QUALITY ASSURANCE -- NON-CONFORMANCE REPORT

Report No: NCR-000682

Reference Description: Excessive width on FCAW single weld pass on Segment 6BW Counterweight connection plate

Subject: NCR No. ZPMC-0649

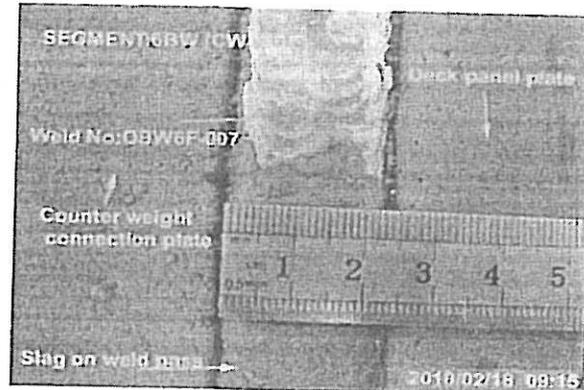
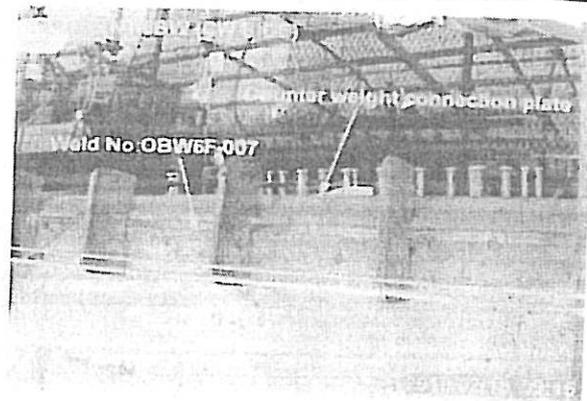
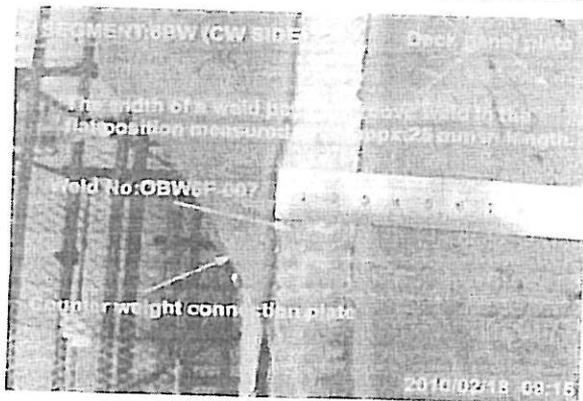
- The width of a single weld pass was measured to be 24 mm.
- This welding was performed in the flat (1G) position.
- The welding process performed was Flux Cored Arc Welding (FCAW).
- The maximum FCAW single weld pass width allowed in this position is 16mm.
- This weld joins the Deck Panel plate to the Counter Weight (CW) connection plate.
- The welding is located on the Deck Plate at segment 6BW CW side.
- This weld is detailed as a complete joint penetration (CJP) weld on approved drawing OBW6F.
- The weld is identified as OBW6F-007.
- Segment 6BW is located outside in the Trial Assembly area.

AWS D1.5 1002 Section 4.14.1.5 FCAW: "When the width of a layer of a groove weld in the flat, horizontal, or overhead position is 16 mm [5/8 in.] or greater, a multiple-pass split-layer technique shall be used."

Perform NDT required to verify weld quality.

Contractor supplied Ultrasonic Testing report verifying the weld in question conforms with Contract weld quality requirements.
